Access Compliance Report

Public Rights-of-Way

(Curb Ramps)

Intersection ID: 5227	Main Street: CAMERON_SPRING_RD	Cross Street: EVENTINE_CT	Location:	E
ADA ID: EF5784CF17B7	Ramp Type: Perp	Initial Pass/Fail: Fail	Overall Compliance: No	Severity Score: 22.5
Codes/Mitigation Info/Possible Solution		Field Measurements/Component Compliance

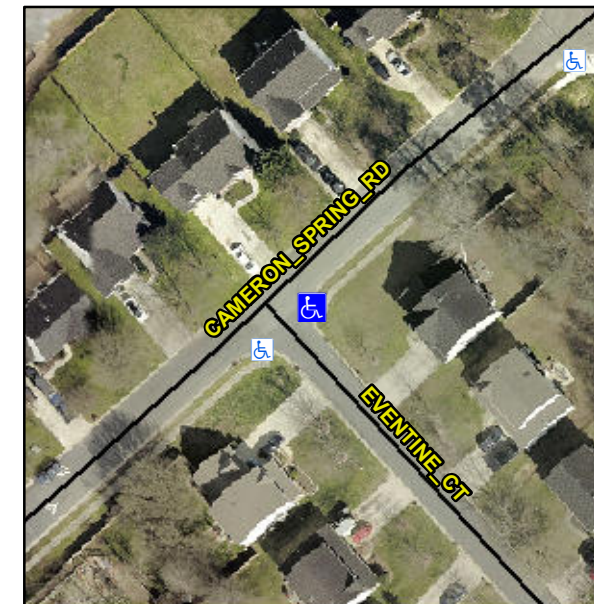
Not Found, R304.5.1, R304.2.2, R304.5.3

Compliance	Description	Data	Compliance	Description	Data
N/A	Ramp Length (in)	47.0	No	Ramp Slope (%)	9.0
No	Ramp Width (in)	43.0	No	Ramp XSlope (%)	4.5
N/A	Flare Type LT	N/A	N/A	Flare Type RT	N/A
N/A	Flare Slope LT (%)	N/A	N/A	Flare Slope RT (%)	N/A
N/A	Flare Traversable LT?	N/A	N/A	Flare Traversable RT?	N/A
N/A	Landing Length (in)	N/A	N/A	DWS Provided?	N/A
N/A	Landing Width (in)	N/A	N/A	DWS Contrast?	N/A
N/A	Landing Slope (%)	N/A	N/A	DWS Length (in)	N/A
N/A	Landing X Slope (%)	N/A	N/A	DWS Full Width?	N/A
N/A	Landing Curb? (Y/N)	N/A	N/A	DWS Offset (in)	N/A
N/A	Shared Landing?	N/A			
N/A	Gutter Ponding?	N/A	N/A	Gutter Slope (%)	N/A
N/A	Gutter Lip Ht (in)	N/A	N/A	Gutter X Slope (%)	N/A
N/A	Painted X Walk1?	No	N/A	Painted X Walk2?	N/A
	X Walk 1 Direction	To SW		X Walk 2 Direction	N/A
N/A	X Walk 1 Width (in)	N/A	N/A	X Walk 2 Width (in)	N/A
	X Walk 1 Slope (%)	3.2		X Walk 2 Slope (%)	N/A
	X Walk 1 X Slope (%)	0.5		X Walk 2 X Slope (%)	N/A

Remove & Replace Entire Ramp.
